Natural Resources Division

Project Review Summary

Prepared for the Environmental Advisory Board

PSDP-24-00502 – Restaurant - 1275 Sun Market Pl, North Port FL, 34288

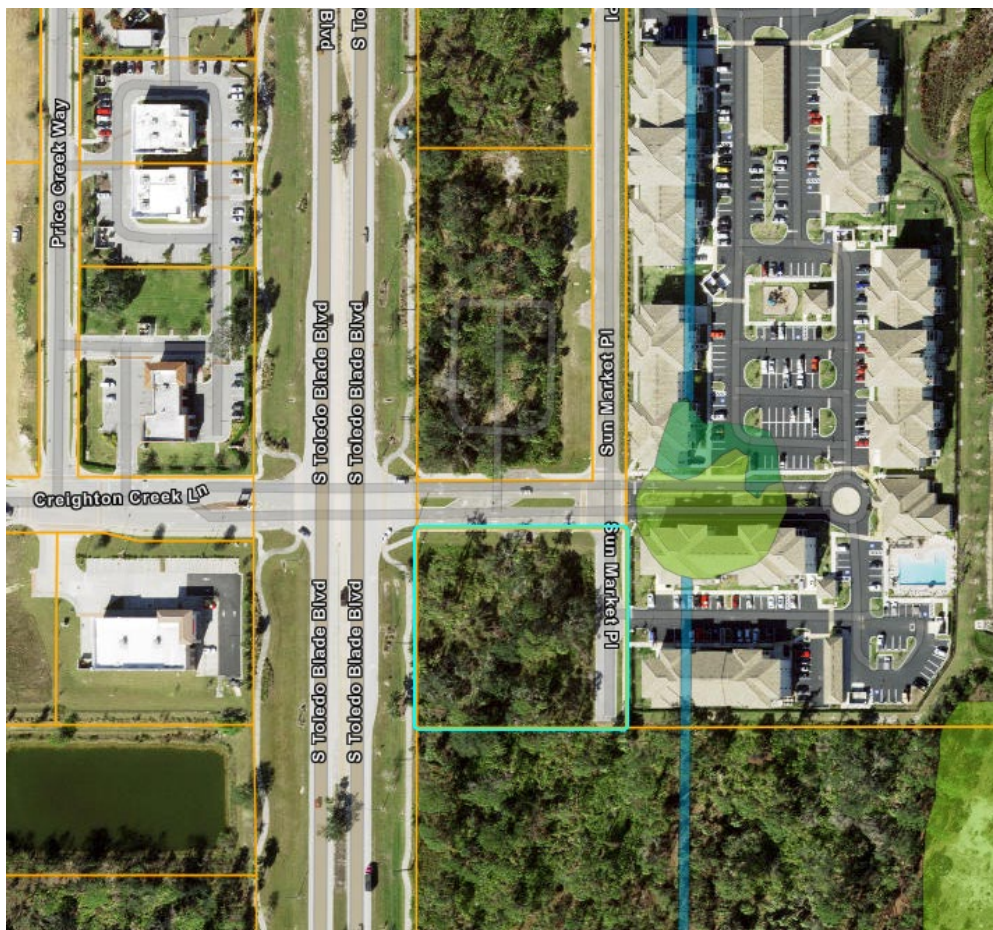
1. A 100% Gopher Tortoise survey must be completed within 90 days of initiating land clearing activities. All gopher tortoise burrows identified on-site must either be avoided by a minimum distance of 25 feet or have all associated tortoises properly relocated. If relocation is necessary, an FWC relocation permit must be obtained, and a copy submitted to the City. Upon completion of relocation activities, a summary after-action report must be submitted to the City, identifying the total number of tortoises relocated to the designated property.
2. If any protected or listed species are present onsite, all construction activities shall cease immediately, and the applicant must obtain all applicable permits or implement avoidance strategies as directed by the Florida Fish and Wildlife Conservation Commission (FWC), U.S. Fish and Wildlife Service, and the City of North Port.

AERIAL SITE PLAN

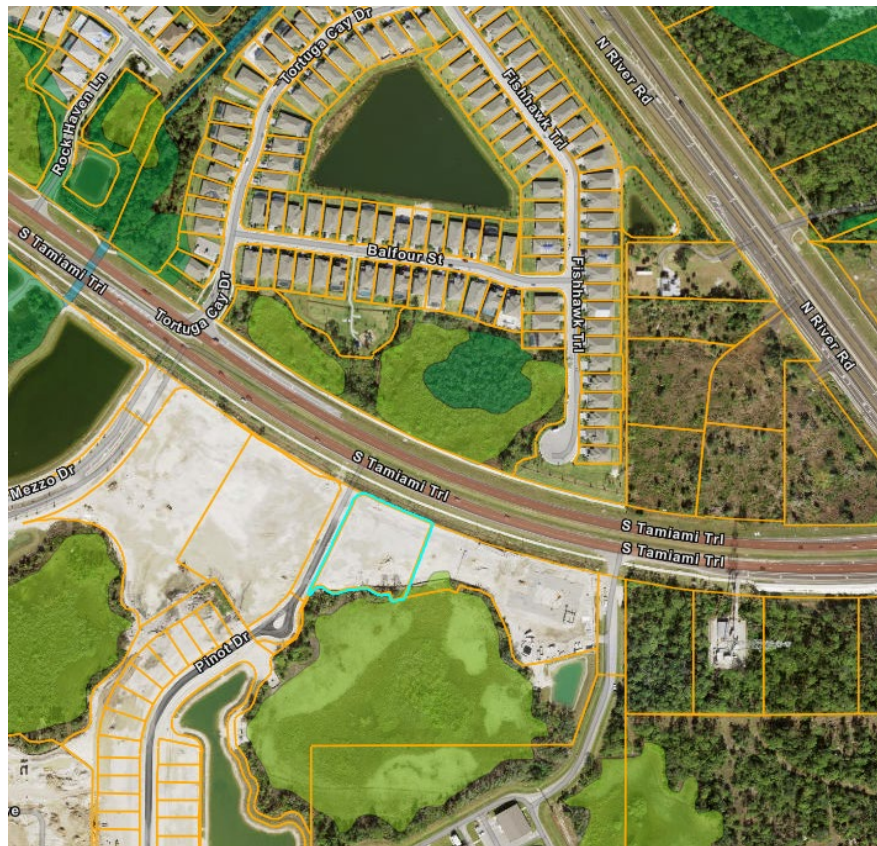
1. A 100% Gopher Tortoise survey must be completed within 90 days of initiating land clearing activities. All gopher tortoise burrows identified on-site must either be avoided by a minimum distance of 25 feet or have all associated tortoises properly relocated. If relocation is necessary, an FWC relocation permit must be obtained, and a copy submitted to the City. Upon completion of relocation activities, a summary after-action report must be submitted to the City, identifying the total number of tortoises relocated to the designated property.
2. If any protected or listed species are present onsite, all construction activities shall cease immediately, and the applicant must obtain all applicable permits or implement avoidance strategies as directed by the Florida Fish and Wildlife Conservation Commission (FWC), U.S. Fish and Wildlife Service, and the City of North Port.
